Coronation Park

Park Master Plan - Submitted for Review
June 11, 2021

Itemized Responses | Parks & Environment Comments on Landscape Submission, Dated March 10, 2021

Site Circulation and Open Space Overview

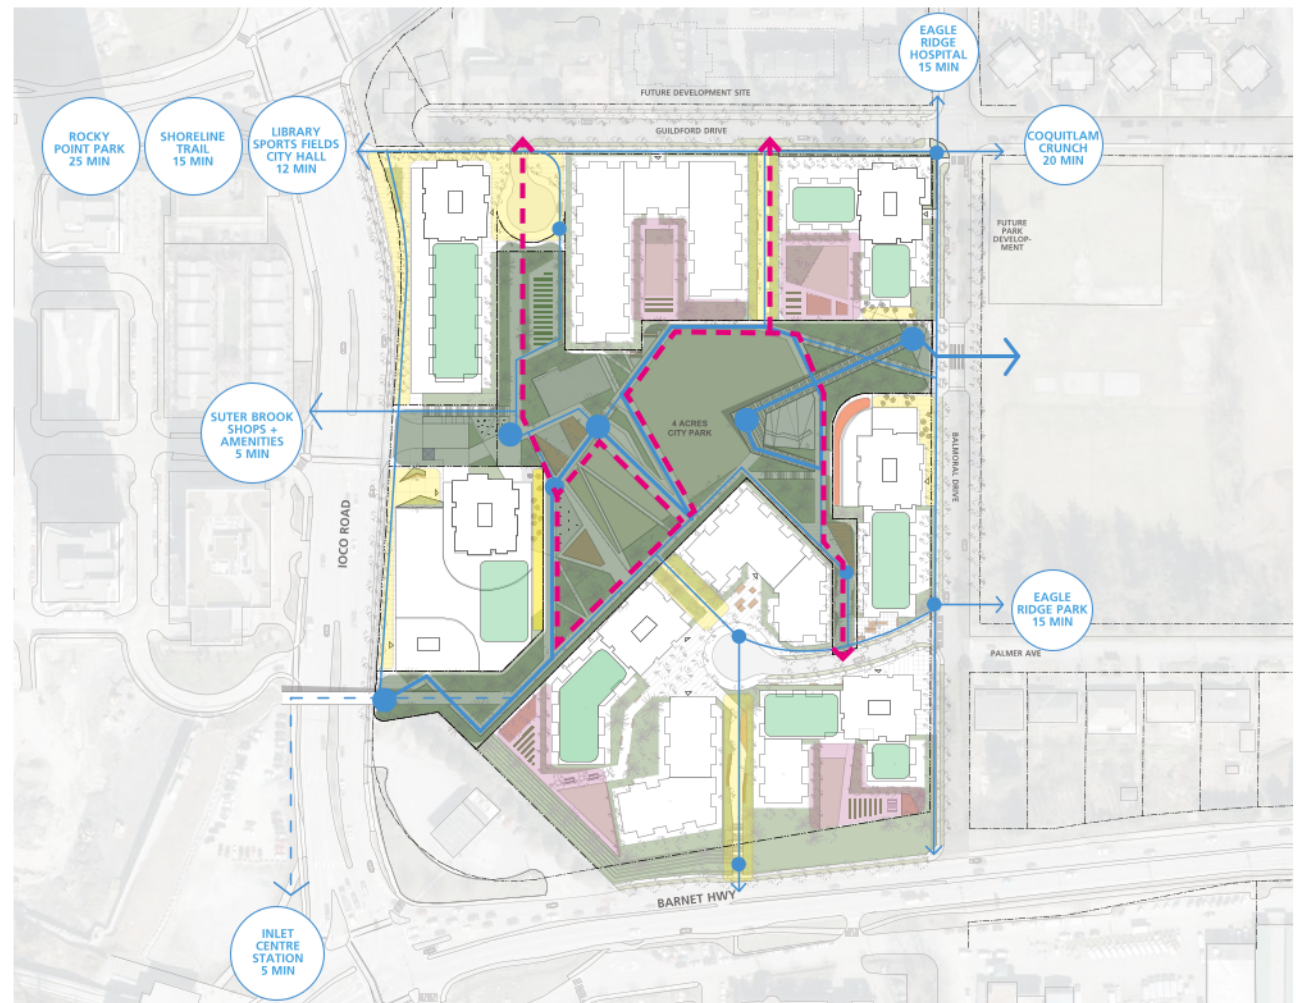
10.0	Access to all park areas is required for daily, weekly and seasonal maintenance, such as litter/garbage, grass cutting and turf maintenance.	Maintenance circulation is considered. Path widths will be adjusted as required to accommodate light City maintenance vehicles. Final review of turning movements will be reviewed if the City can provide maintenance vehicle data. Refer to Site Circulation and Open Space Overview (page 5) for locations and details.

Coronation Park Plan Comparison

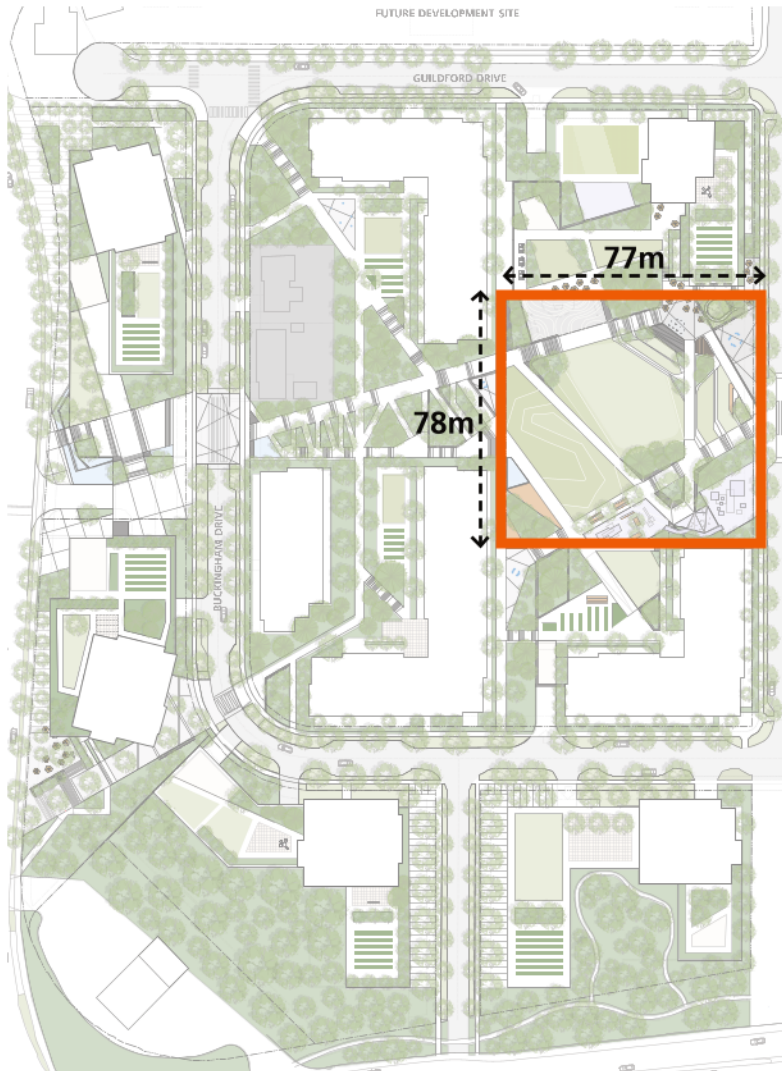
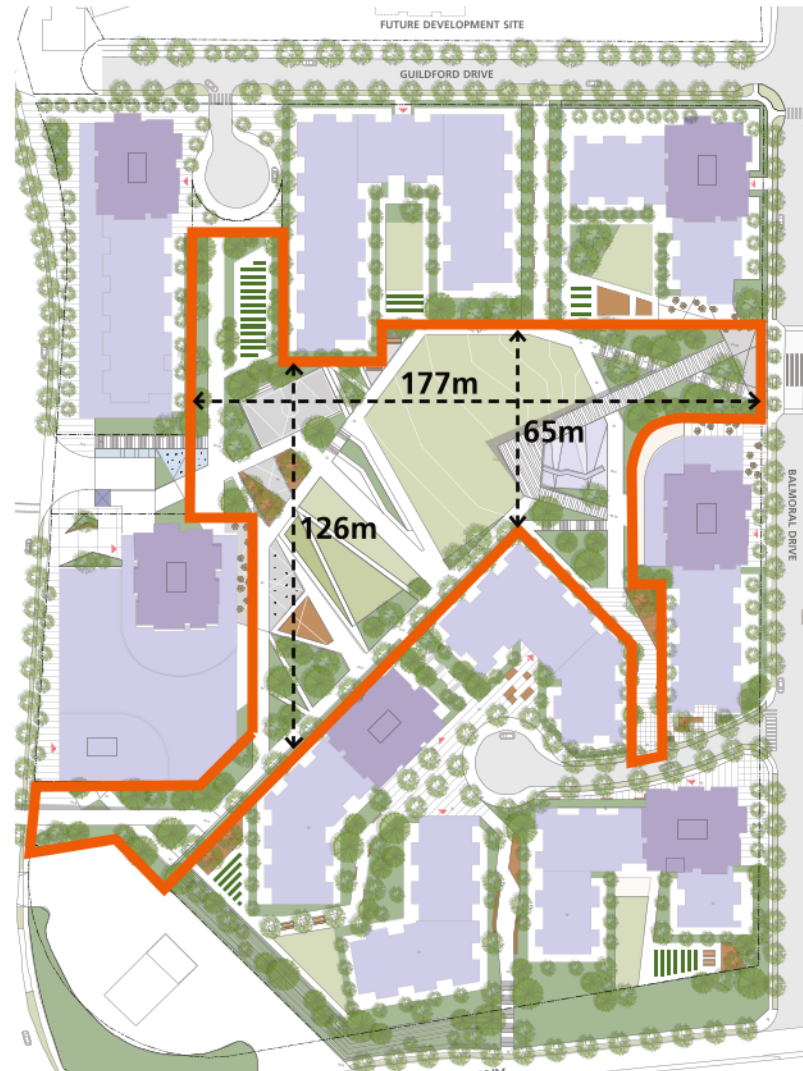
Item	Comments / Recommendations	Applicant Response
0.0	<p>The 1.5 acre park should allow for both active and passive programming. One of the challenges with planning for a park of this size is that it cannot be all things to all people and small parks limit options – some activities will not fit. Even with a good plan, the option to include active recreational space will still be limited. It may be worth looking at several design concepts at a high level to better understand the tradeoffs – what are the footprints of various features and what combinations can be accommodated together?</p> <p>The following specific comments are not provided in any order of implied importance. Also, some of the comments are intended to be addressed if the project moves to the rezoning and development permit stage.</p> <p>It is also recognized that, as noted above, some of the desired elements may not be able to be physically or technically accommodated given the size of the park, grades and other considerations. Where they cannot be accommodated, that should be noted along with an explanation as to why.</p>	<p>The area of the park has been increased from 1.5 acres to approximately 4 acres in the redesigned layout. We can create a meaningful and exciting park space with a variety of active and passive programming elements that will accommodate a variety of park experiences. We have explored footprints for tennis, soccer, dog parks etc. and determined these program elements are physically too big and/or the site gradients cannot accommodate them without dominating the park.</p> <p>A wide ‘flex lawn’ area allows space for throwing a frisbee or a ball with friends, setting up a badminton net, picnicking or sunbathing. Combining the ‘public plaza’ with splash pad jets and integrating play and program elements into the slopes are examples of how we might integrate a variety of experiences into a modestly-sized park on a significant gradient.</p>

Illustrative Park Sections

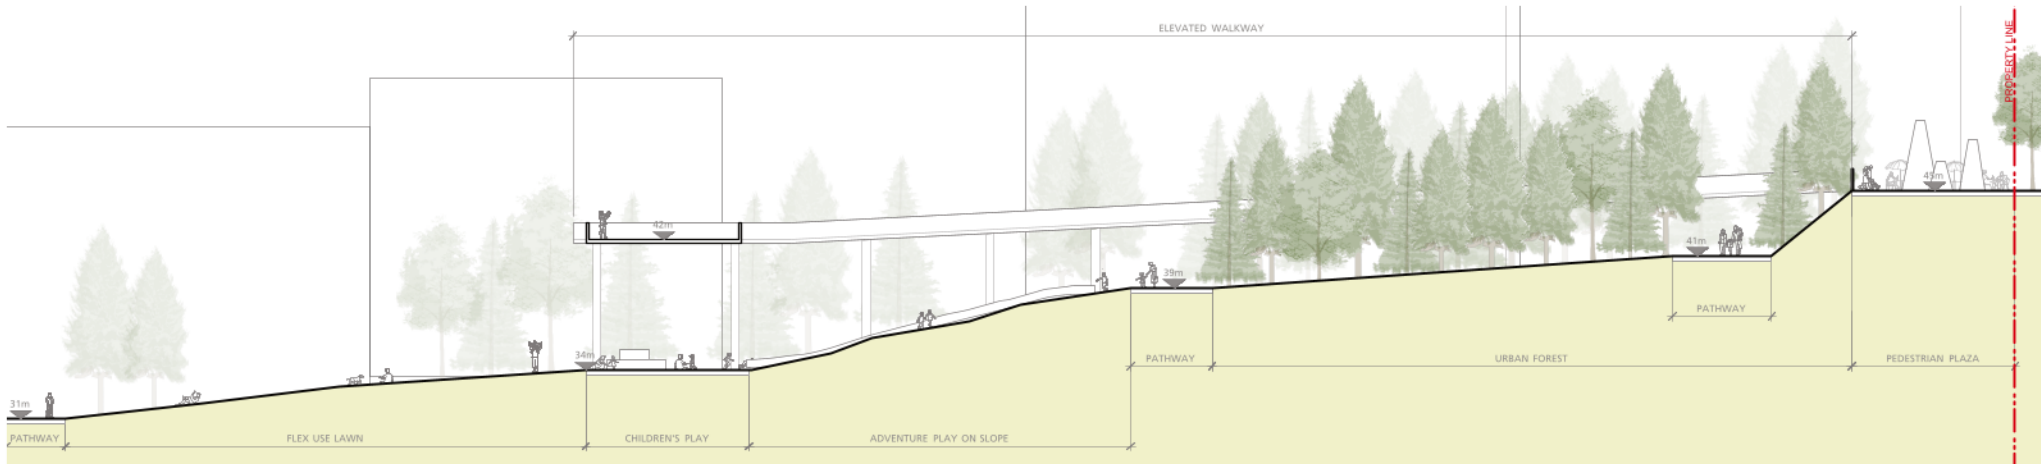
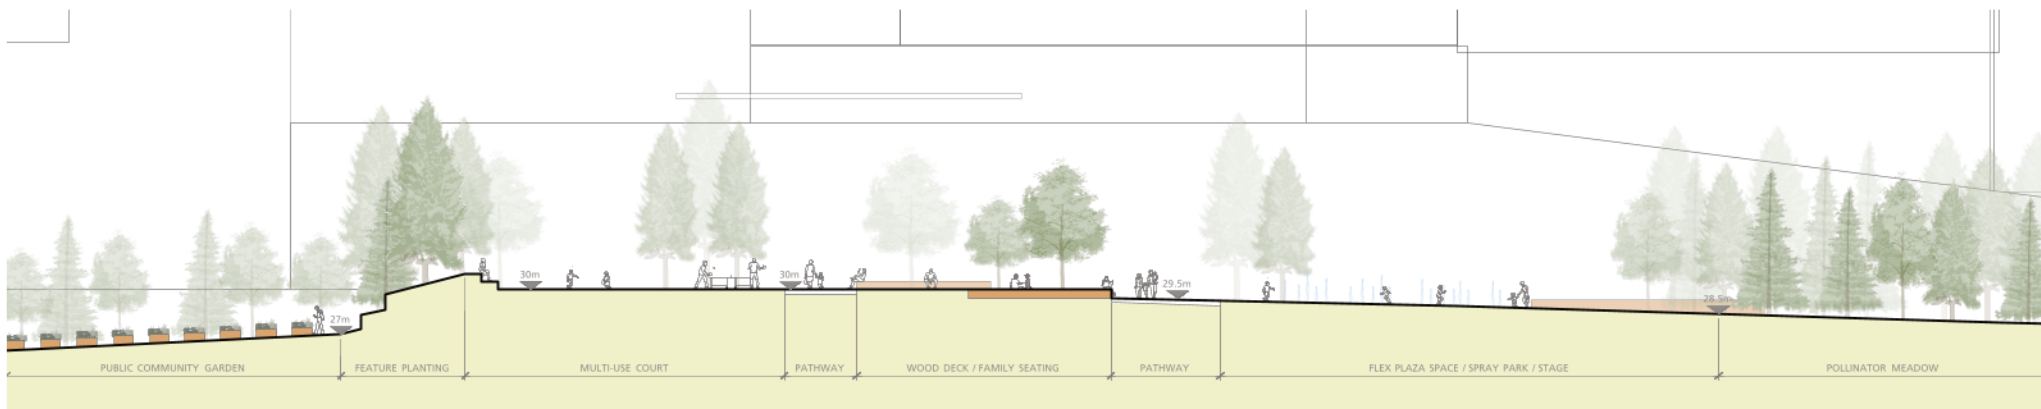
Item	Comments / Recommendations	Applicant Response
4.0	Ensure universal accessibility and demonstrate that this is being achieved through cross-sections, etc.	A major driver for the park design is the need to provide barrier-free pedestrian circulation for all users as they negotiate the extents of the park and all elements within. Given the slope gradient of the site, barrier-free access will be circuitous by necessity. An overhead 'elevated walkway' / ramp has been incorporated into the design to ease gradients and provide excitement and overlook within the park. Site cross sections are provided in this document to demonstrate the design response to the site gradient.
